## QUALITY ASSURANCE -- NON-CONFORMANCE REPORT

**Report No:** NCR-000838

**NCR #:** ZPMC-0800

**Reference Description:** Missed Transverse UT Indication

-The weld is identified as SB020-080-004.

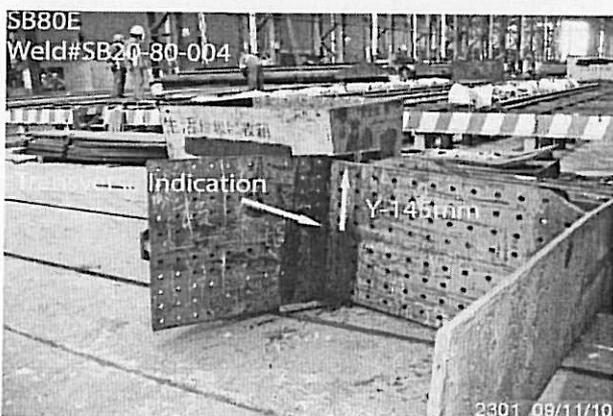
-One (1) Class "A" transverse indication with crack like characteristics measuring approximately 15 mm in length.

-The db rating is +5.

-The weld is a Complete Joint Penetration (CJP) Tee Joint joining the suspender bracket vertical connection plate (X57BC) to the top plate (X53B).

-The thickness of the vertical connection plate in way of the weld is 22mm.

-The "Y" location is approximately 145mm measured from the end of the joint (Looking West).

-The indication is clearly marked by QA near the weld.

The Notice of Witness Inspection Number (NWIT) is 006632. The indication is located inside the area that has been previously tested and accepted by ZPMC (QC) personnel. ZPMC's QC personnel performed 100% UT inspection of this weld, due to indications found in the required 25% length of testing.

Contractor repaired the indications with WWR document support. UT was performed after repaired. UT report showed the weld is acceptable. Contractor also identified the inspector, and issued an internal NCR to him. His performance is monitored.
